APPEAL REPORT

East Los Angeles Area Planning Commission

Case No.: DIR-2017-4229-SPP-1A
CEQA No.: ENV-2017-4230-CE
Incidental Cases: None
Related Cases: None
Council No.: 1-Cedillo
Plan Area: Northeast Los Angeles
Specific Plan: Mount Washington-Glassell Park Specific Plan
Certified NC: Glassell Park
GPLU: Low Residential
Zone: R1-1

PROJECT LOCATION: 3721 North Kinney Drive

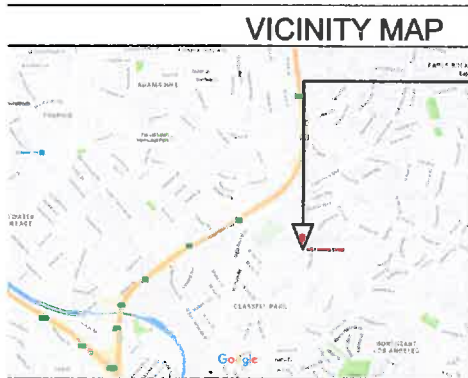
There is a discrepancy between the lot area on ZIMAS (5,140.7 square feet) and the lot area shown on Exhibit A (5,463.10 square feet). The use of the larger figure allows for more square footage than that which should have been allowed.

Following standard procedure, Planning Staff utilized the square footage on the survey provided as part of the case filing, which identified a lot area of 5,463.10 square feet.

EXHIBIT "A"
Page No. 2 of 7
Case No. DIR-2017-4229-5PP

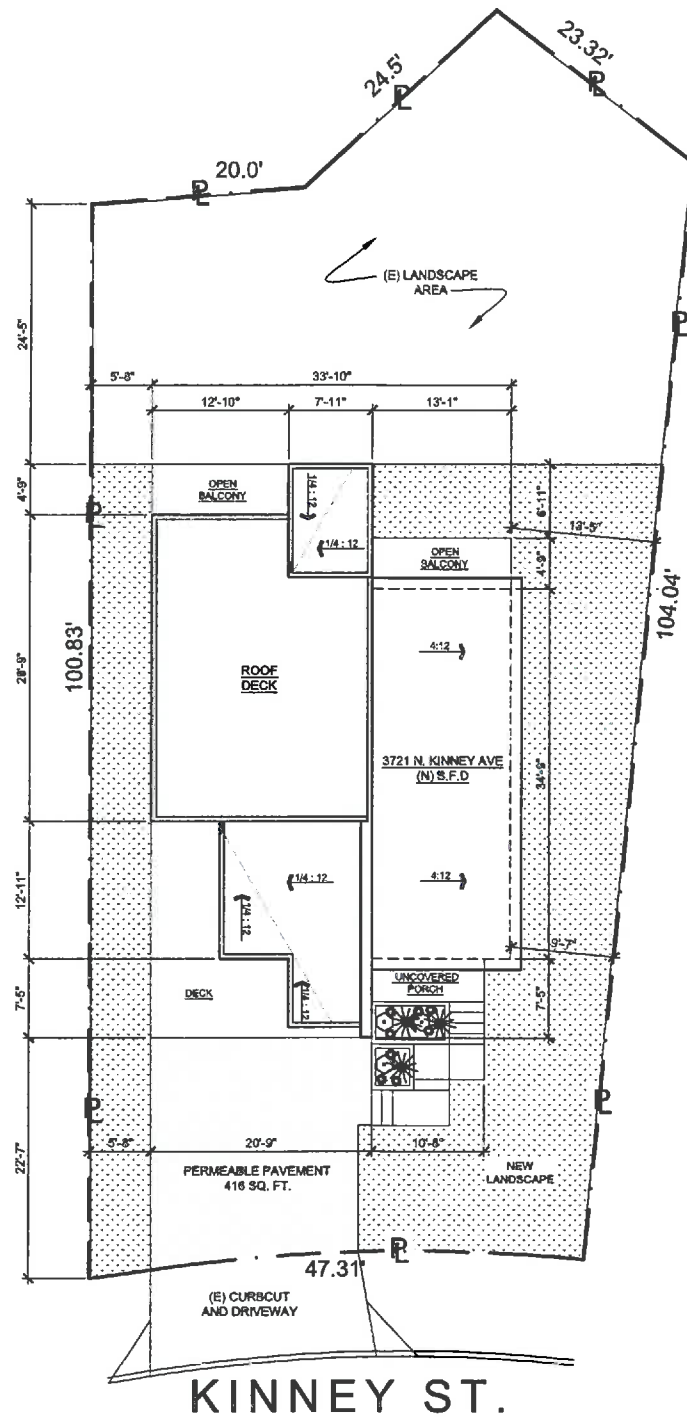
The 22-foot, 7-inch setback in the plan for the site in concern drastically differs from the Prevailing Front Setback Calculation of 4 feet, 7 inches. Having a proper setback is critical in retaining the character and consistency of this neighborhood. We would like to request for the front setback of the site is within city/neighborhood guidelines please.

- 3) Setback: The 22'-7" setback in the plan for the site in concern drastically differs from the Prevailing Front Set Back calculation of 4'-7". Having proper front setback is critical in retaining the character and consistency of this neighborhood. We would like to request for the front setback of the site is within city/neighborhood guidelines please.

The Specific Plan dictates that front yards should be consistent with the others in the neighborhood. The architect calculated an average front yard of 4 foot 7 inches, yet provides a distance of 22 feet 7 inches. This excessive setback pushed the home much further into my clients' view. It is likely that the large setback is for the proposed home to capture more view, but should not be at the expense of the neighbor. The acceptance of this front yard is clearly an error and on its own should require the Planning Commission to deny the project.

However, there is no Specific Plan Prevailing Setback requirement for this project because there are not enough lots to make such a calculation. The minimum number of lots required for the Specific Plan Prevailing Setback calculation is two (2) lots. The criteria removes properties that do not contain the required parking spaces in accordance with LAMC Section 12.21 A 4(a), which requires that all one-family dwellings in the R1 Zone have a minimum of two (2) automobile parking spaces. The permit record (Exhibit F) for the house on Lot 42 at 3717 North Kinney Street, which was built in 1947, shows that there is only a one car garage. Therefore, Lot 42 must be excluded from the Specific Plan Prevailing Setback calculations, leaving only Lot 43. Given that there are not enough lots for the Specific Plan Prevailing Setback calculation, the Front Yard Setback requirement defaults to the requirements of LAMC Section 12.21 C.10, with which the Project complies. The language in the Findings was amended to reflect this explanation.

ROOF TOP FLOOR PLAN

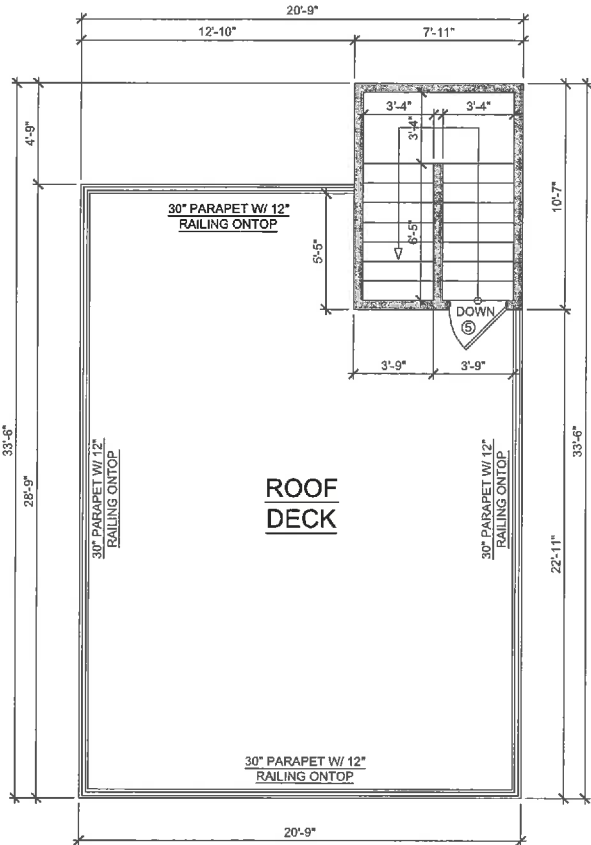
After examining the plans, we believe the roof deck will severely compromise our privacy as well as the future occupants of the proposed project. The height of the proposed roof deck is at eye level to our deck where we spend the majority of our time. Any person standing on the roof deck would be able to see directly into our home. Also, there are no roof decks in any of the houses in the neighborhood. We would like the plans to be changed to exclude the proposed roof deck.

- 2) Roof deck: the proposed plan includes a 550 sq. ft. roof deck. After examining the plans, we believe this roof deck will severely compromise our privacy as well as the future occupants of the proposed project. The height of the proposed roof deck is at eye level to our deck where we spend the majority of our time. Any person standing on the roof deck would be able to see directly into our home. Also, there are no roof decks in any of the houses in the neighborhood. We would like the plans to be changed to **exclude** the proposed roof deck.

View Impact

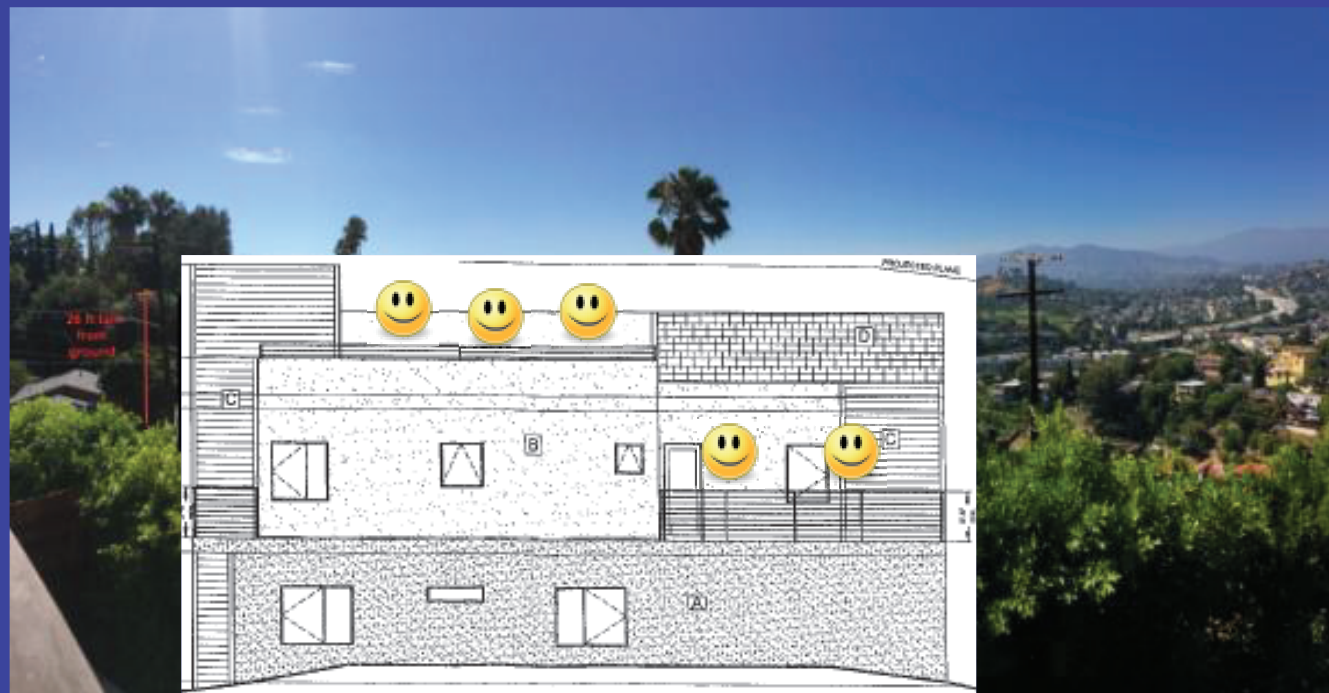
- Privacy will be eliminated due to the extensive rooftop deck which is exactly in their viewshed. Other homes in the area do not have rooftop decks and this should be viewed as an anomaly and not acceptable.
- The size of the home is dramatic and uses strategic design elements to create a much larger home than the maximum FAR. The decks and porch add additional mass that create a total of 3,522 square feet of gross area, nearly 900 square feet than the allowable floor area. The home is much larger and impactful than the FAR represents.

Project Ignores Prevailing Front Yard Requirement

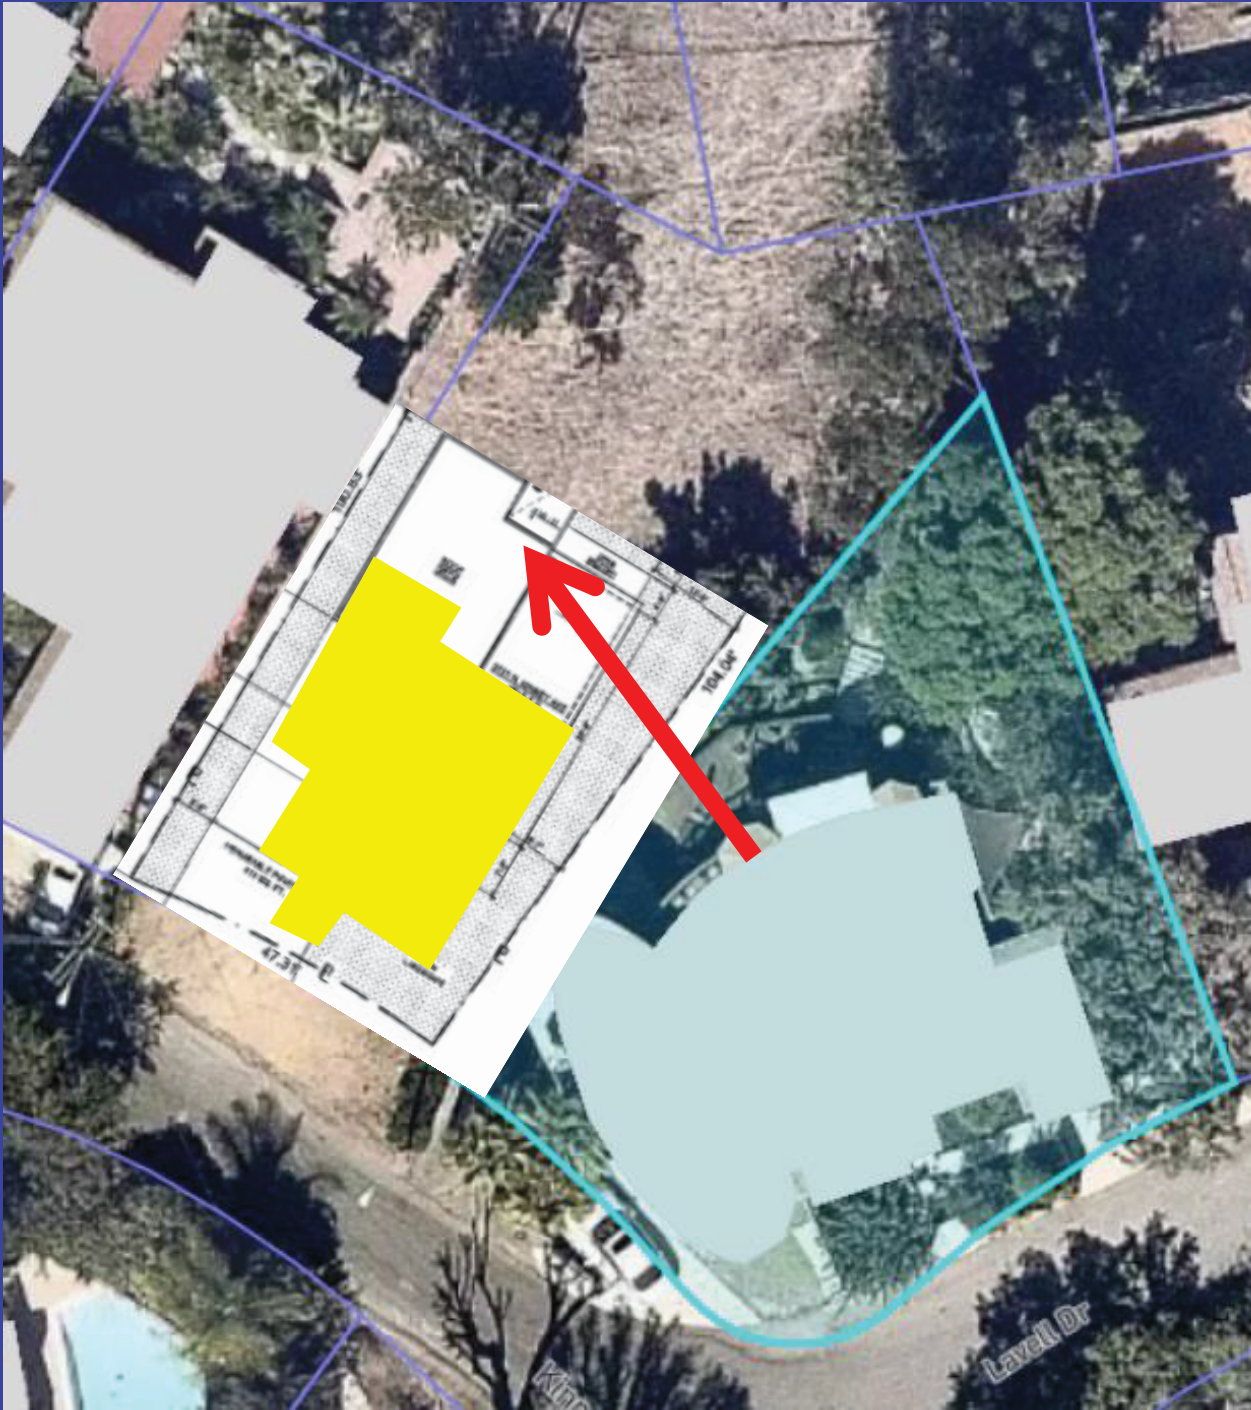
- The Specific Plan dictates that front yards should be consistent with the others in the neighborhood.
- The architect calculated an average front yard of 4 foot 7 inches, yet provides a distance of 22 feet 7 inches. This excessive setback pushed the home much further into my clients' view.
- It is likely that the large setback is for the proposed home to capture more view, but should not be at the expense of the neighbor. The acceptance of this front yard is clearly an error and on its own should require the Planning Commission to deny the project.
